Submission to
The Independent Planning Commission
regarding
**Pathways Cremorne Seniors Housing
(SSD-49472213)**

By
Fiona Gracie
Founder
Cremorne Conservation Group

Montage of 4 of the 6 heritage cottages, the RACF and Building 2.

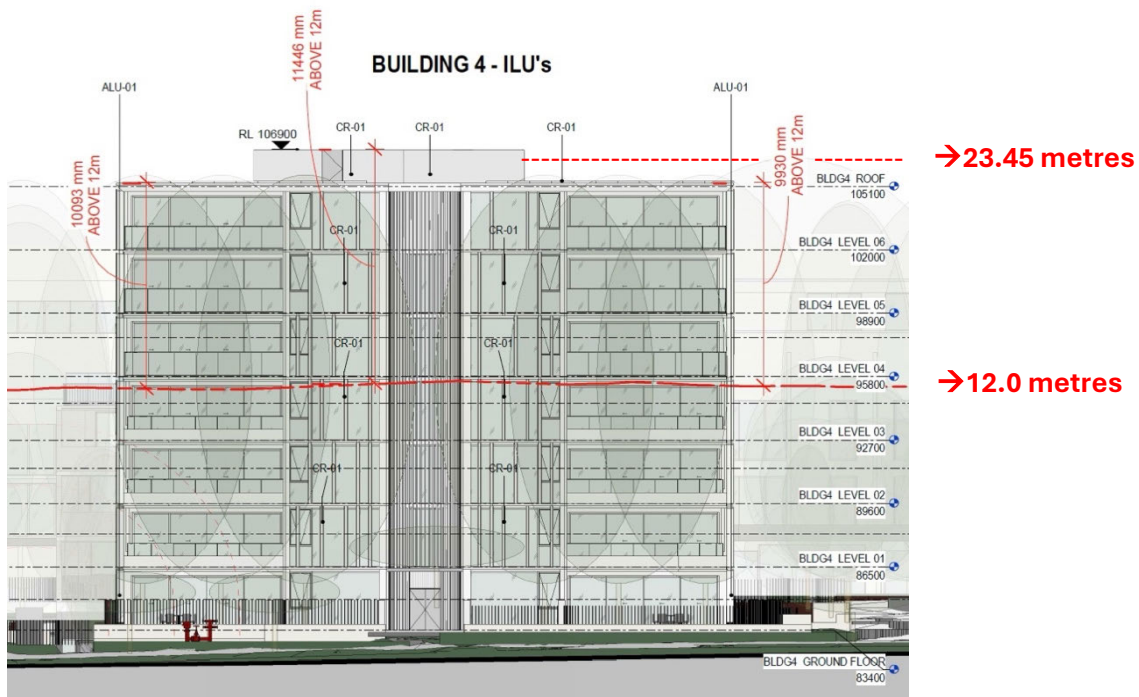
The erection of the 4-storey RACF immediately behind the six cottages, and the adjacent 4-storey ILU Building 2 are imposing modern structures that detrimentally affect the streetscape character and significance of the heritage listed items. The Pathways buildings are excessive in bulk and scale, dwarfing the single storey turn-of-the-century federation cottages.

(Cremorne looking south: Building 04 is shaded blue)^{Error! B}
ookmark not defined.

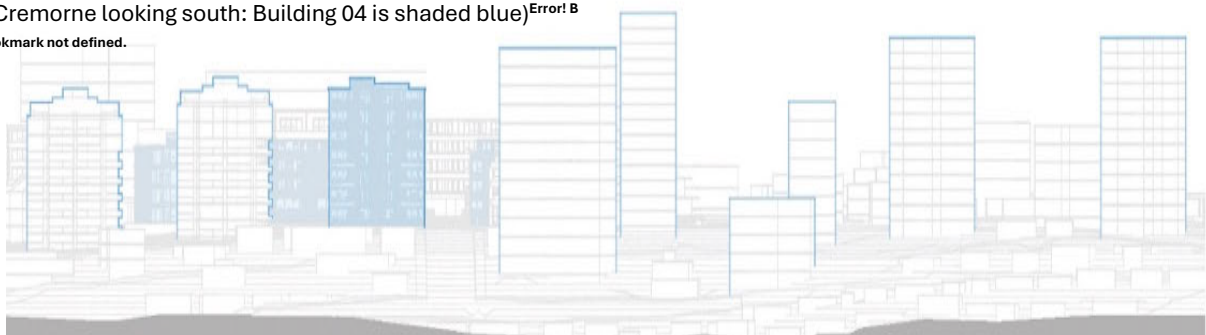
The report states (*Building 4*) design takes into consideration the scale and character of nearby apartment complexes... that respects the built form of its two immediate neighbours to the east. Further, the statement *building 04 sits comfortably within the range of heights of the taller buildings in the area* is misleading.

The existing high-rise developments shown below were constructed during 1960-1970s when the now-redundant LEP controls permitted such heights. These structures would not be permitted under current LEP controls. ILU Building 4 is excessive in scale and does not conform to the desired future character of the area.

1. Reduce the height of Building 4 to 12m height in line with the Housing SEPP 2021 (Seniors).
2. Incorporate setbacks on Floors 3 and 4 of the RACF and the east side of Building 2 to reduce bulk and scale of the streetscape behind/ beside the six cottages. These setbacks will improve solar access and ventilation to the north and west side of the adapted reuse cottages.
3. Move the setback of the bounded balconies on the Parraween Street ground floor units of Building 2 and 3 to at least 5 metres.

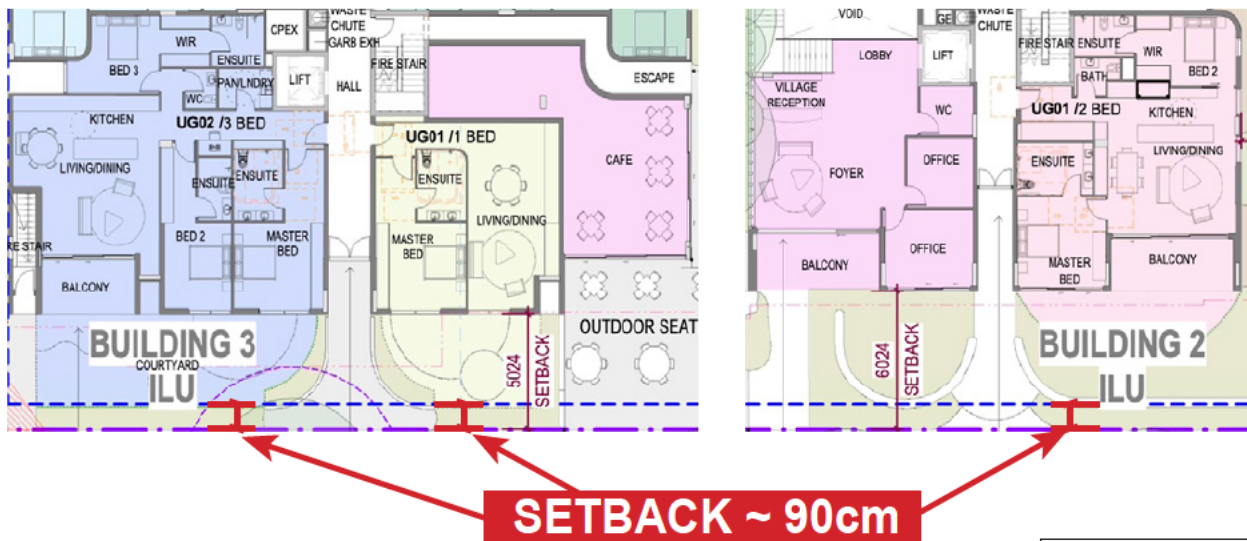
The existing building line of both turn-of-the-century dwellings and modern apartment buildings along the north side of Parraween Street retains a 6-7 metre setback to incorporate front yards (ie there are no balconies beyond the building line on the ground floor). Disappointingly, with the removal of the 8th floor of Building 4, the amended plans replaced the federation style Parraween streetscape, that the proponent argued was important for the local community, with modern structures. The ground floor units of Building 2 and 3 now have very small 90cm setback from the footpath to the boundary of an enclosed balcony wall.

The plans (above) clearly show the outline of balconies, and the report table above identifies the area of balconies, not open space.

The plans clearly depict the spaces as balconies on the ground floor units of Building 2 and 3, and therefore do not conform with the ADG nor the DCP, and is contrary to the statement from Ms Christy, Gyde Consulting. Under these circumstances the proposed 90cm balcony setback is unacceptable. If approved, the residents of those units, and the community, will be negatively impacted with issues around privacy, noise and security. Balconies should conform to the controls and ADG design criteria, and be at least 5 metres from the footpath integrated into the building line setback.

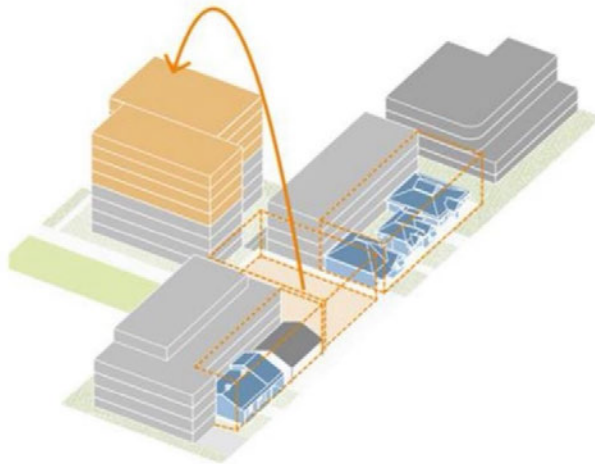
However, the through-site link at the Parraween St end (as shown in the image) is a hard surface area with hard seating, without a tree canopy to provide shade nor appropriate cover from the elements.

In a street where parking is at a premium, where will the public, who use this outdoor area, park? Will basement parking be made available for the public use? It is noted that no visitor parking is proposed.

8. To make the throughway a desirable area for residents and community to enjoy:
 - Incorporate man-made shade (given lack of deep soil) and provide appropriate cover from the elements at the Parraween St end.

- Make outdoor seating comfortable for seniors and people with disability by incorporating side arms, backs to seats and rounded bases.
9. Contract a landscaping company employing a qualified horticulturalist (that does not subcontract) to undertake regular garden maintenance and replant when necessary.

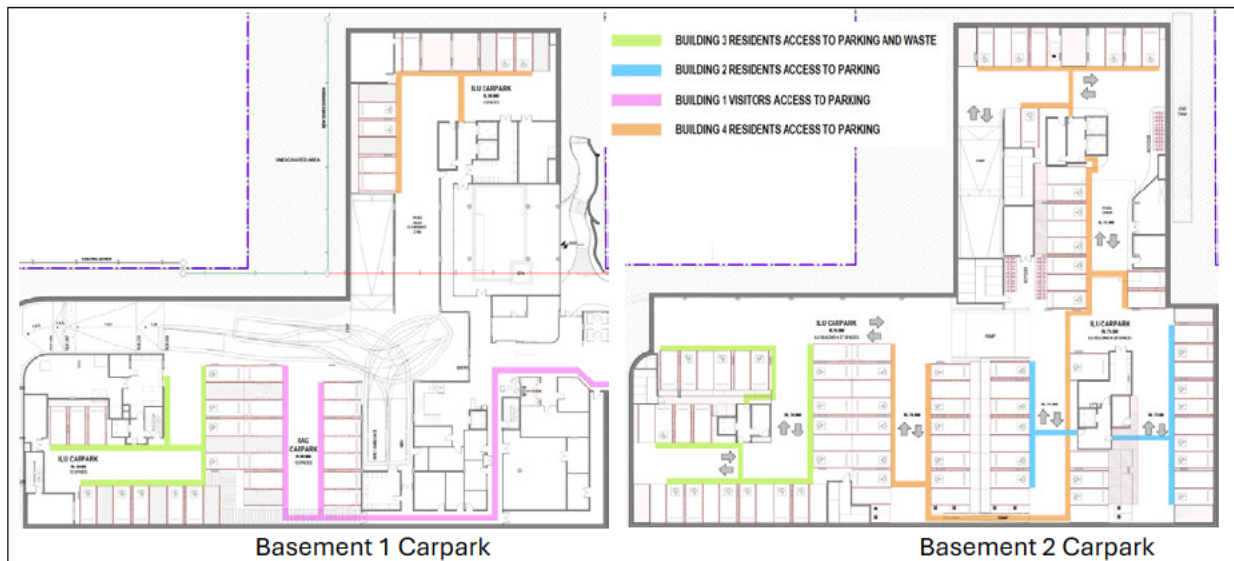
During peak hours, Parraween Street is a recognised 'rat run' between MacPherson Street and Winnie Street. In fact, Council identified a need for traffic calming scheme in the 2019 LATM Action Plan.

Parraween Street currently accommodates at least 500 private car spaces which will increase as further private development takes place. Council's Parraween Street public car park at the eastern end of the street will increase spaces from 63 to 161 after Council's approved upgrade and construction of a new childcare centre, affordable housing development and pocket park is completed.
